May 26, 2017

TO : All Bidders
FROM : George M. Wiens
PROJECT : CTE Classroom Addition
1615400.41
SUBJECT : Addendum 1
DSA : 04-115755 / 33-H18

DRAWING NUMBER: **AW2.1**

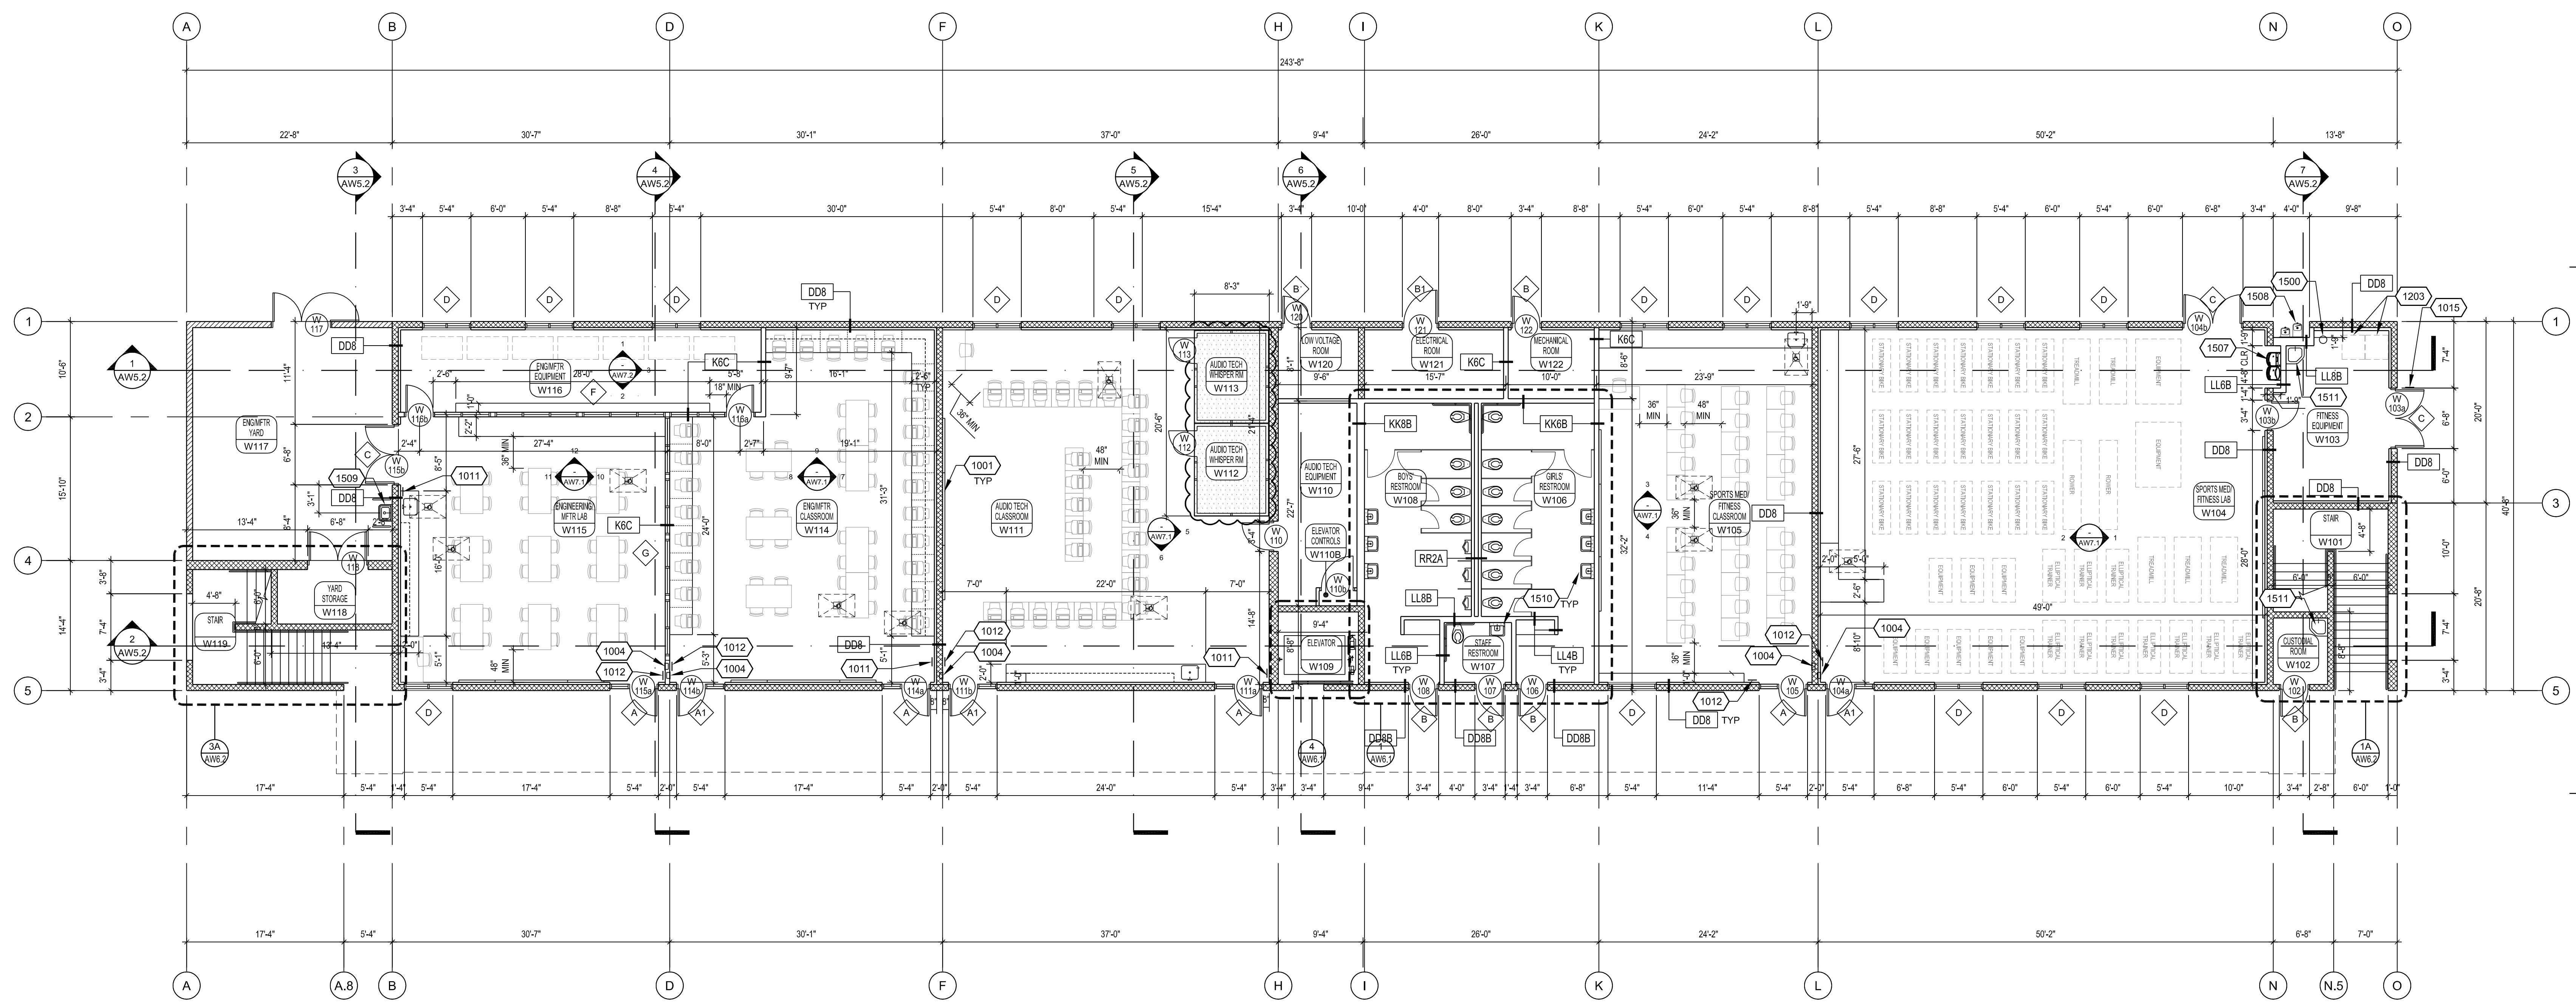
- A. Revise as indicated in the clouded area labeled Delta 1 on the attached AW2.1.

DRAWING NUMBER: **AW3.1**

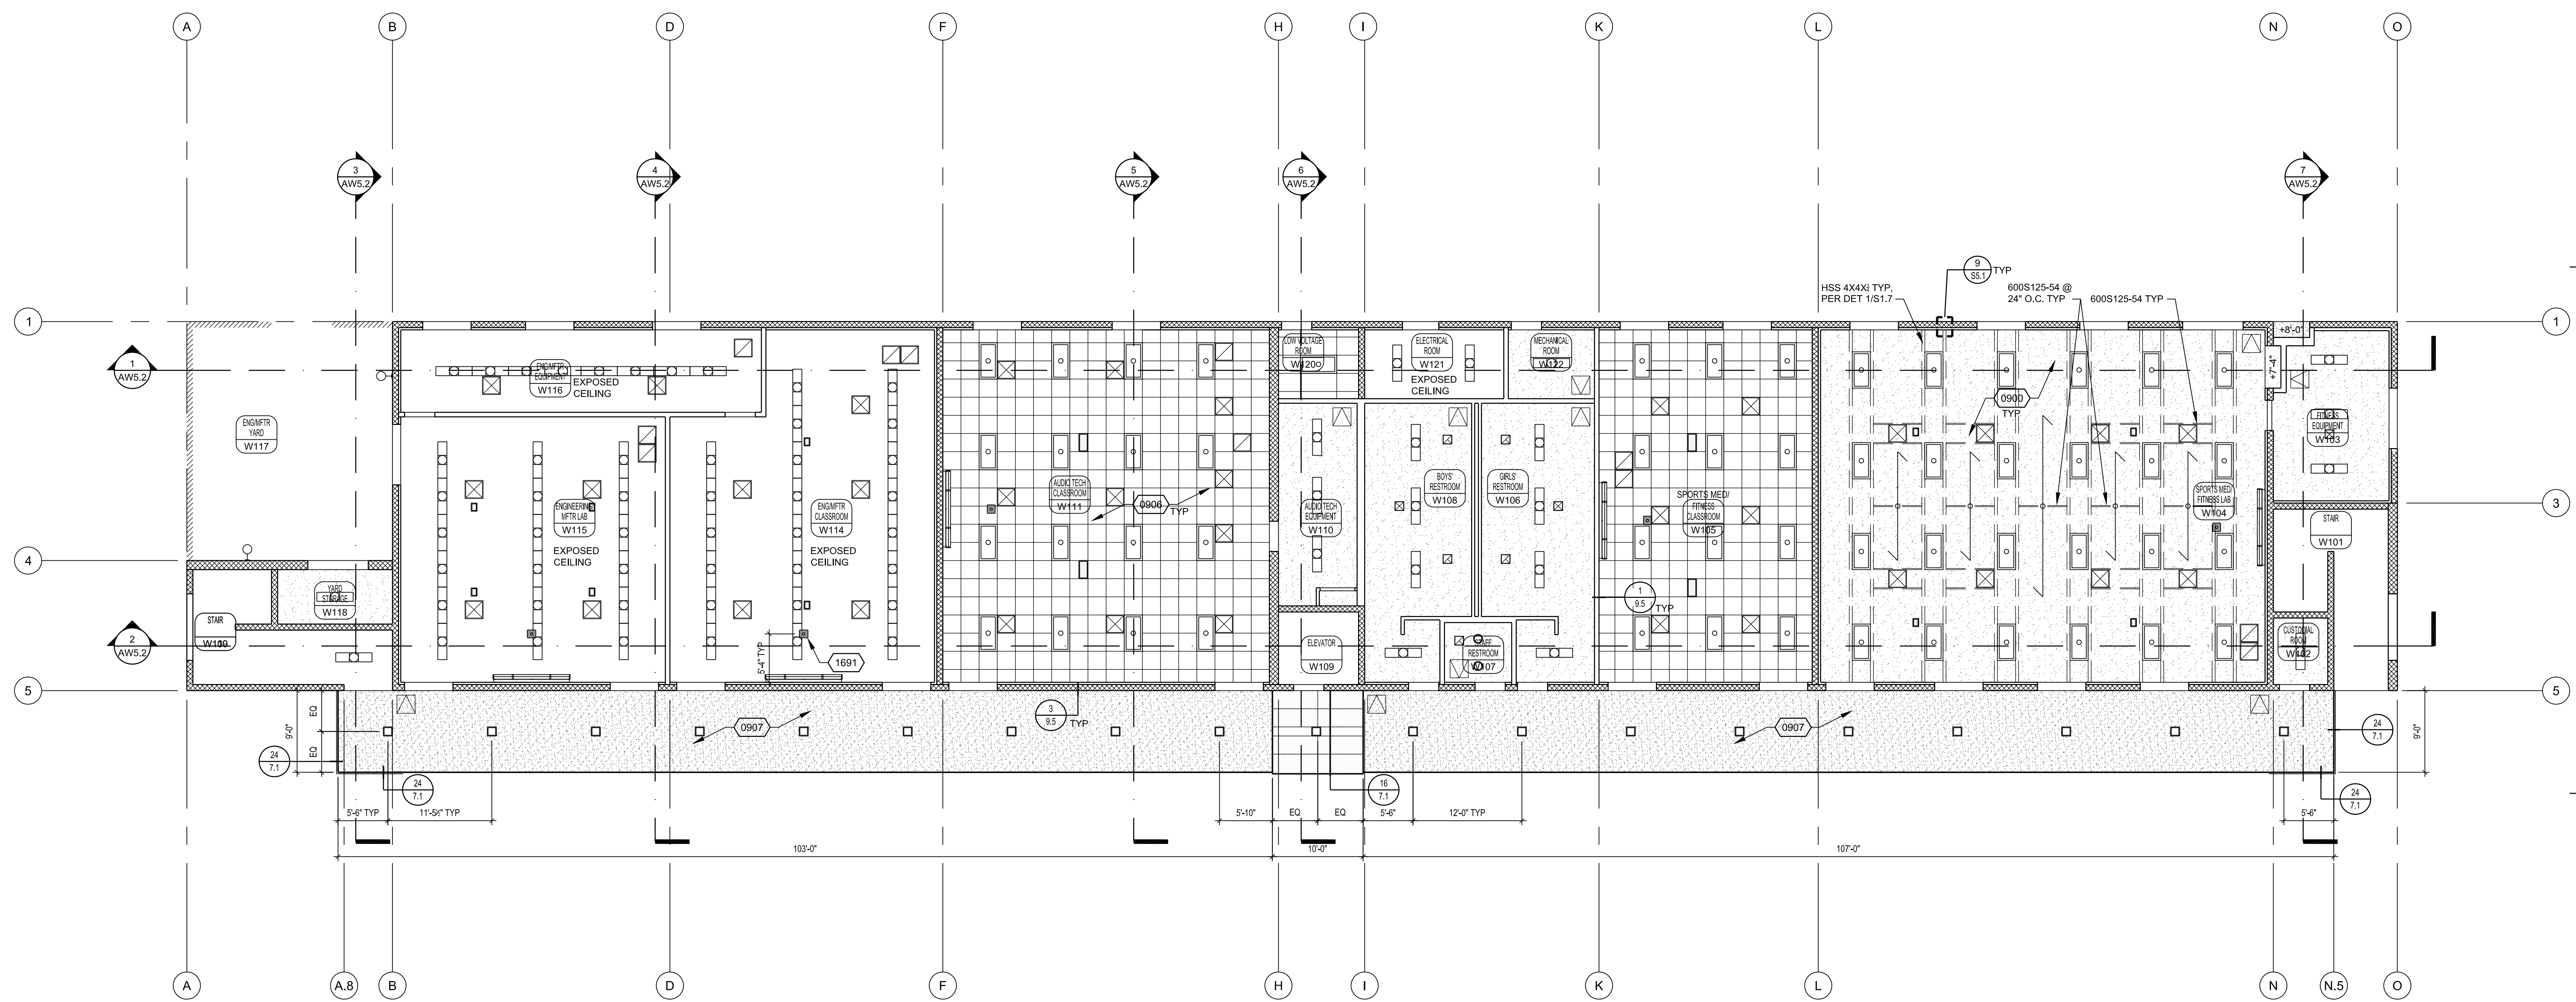
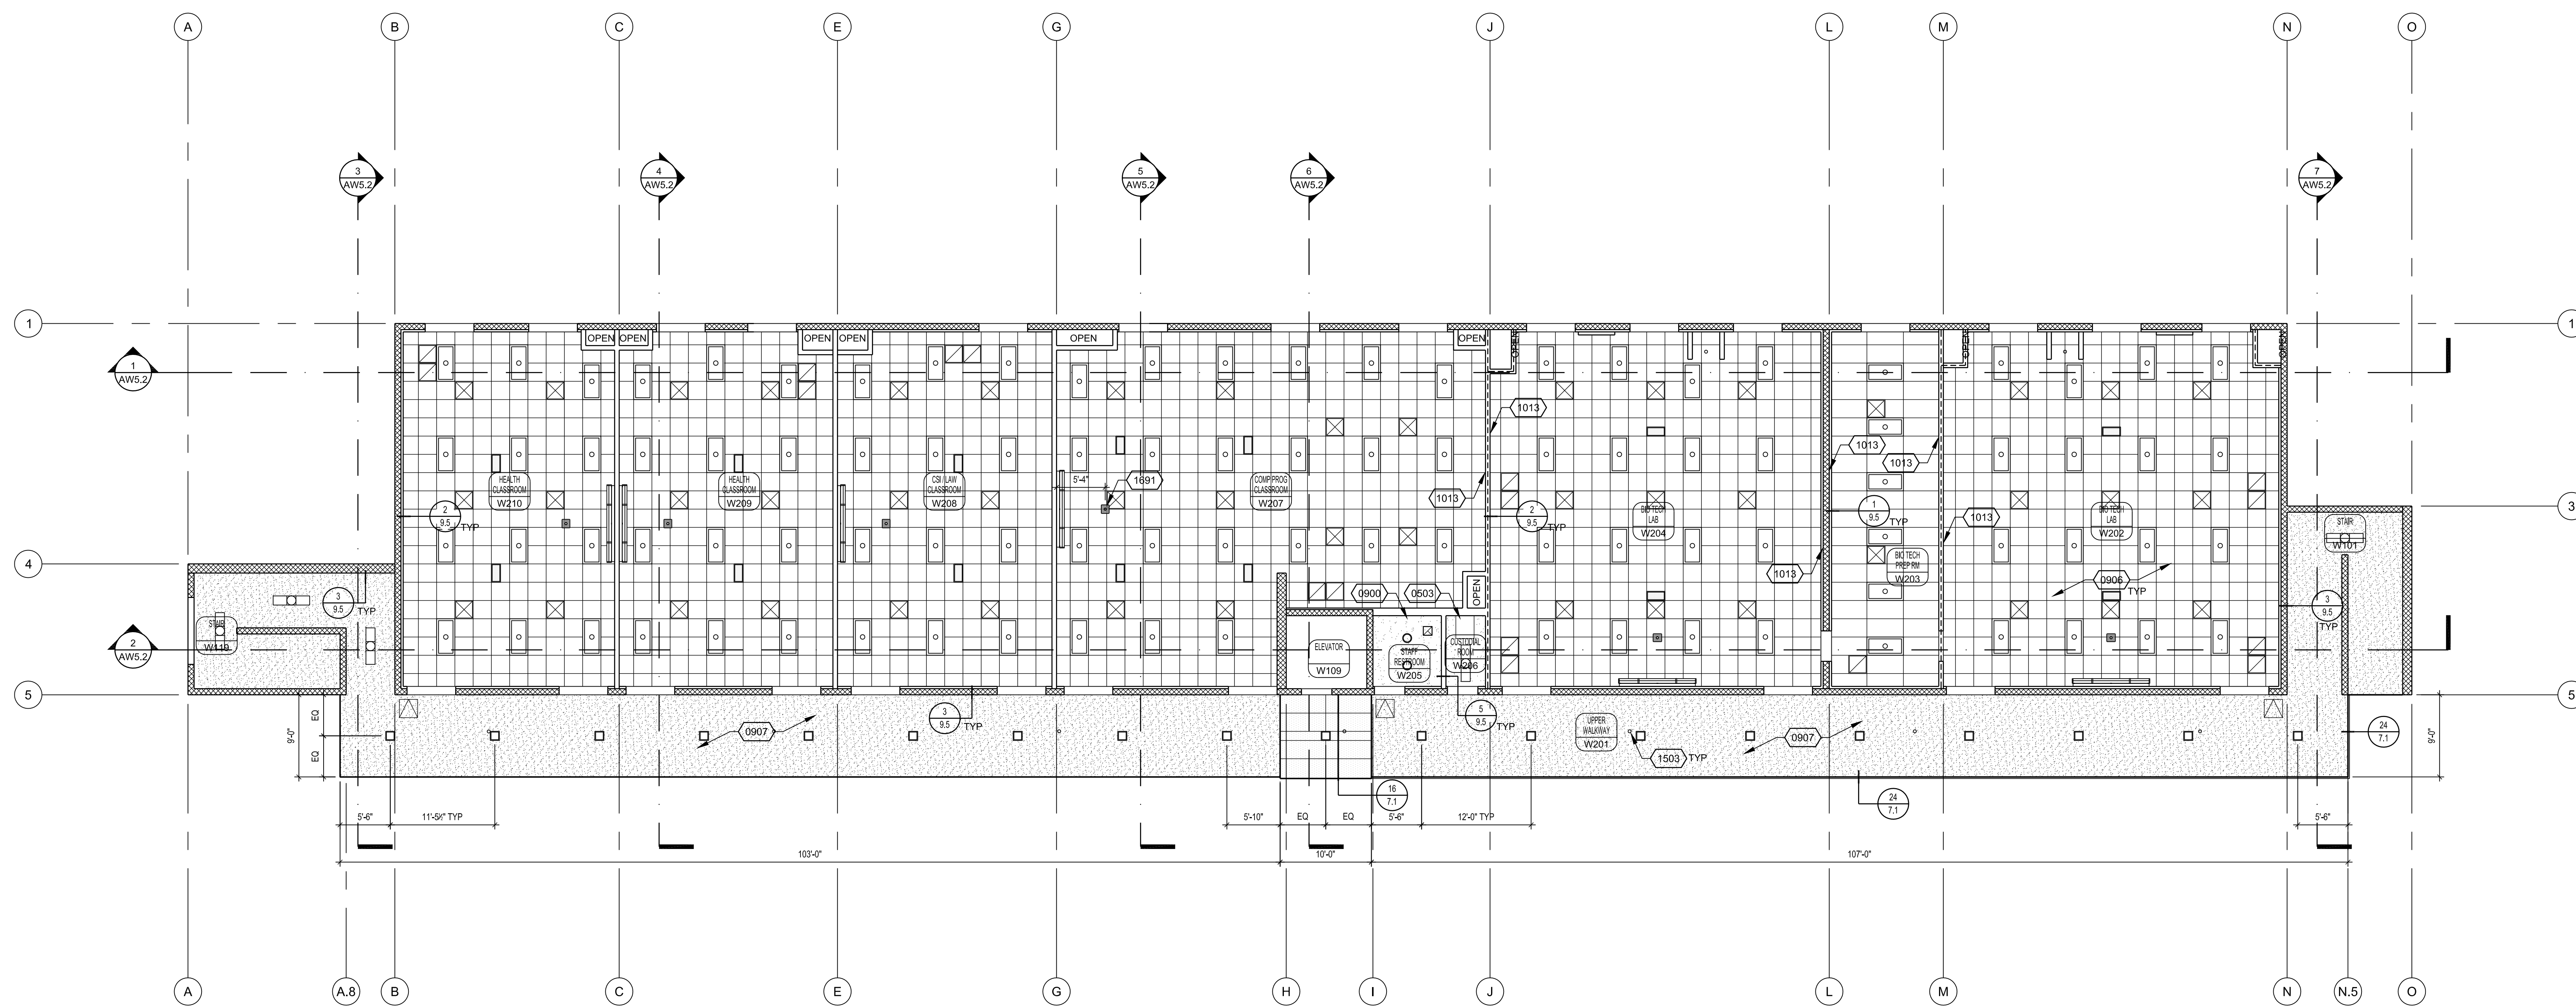
- A. Revise as indicated in the clouded area labeled Delta 1 on the attached AW3.1.
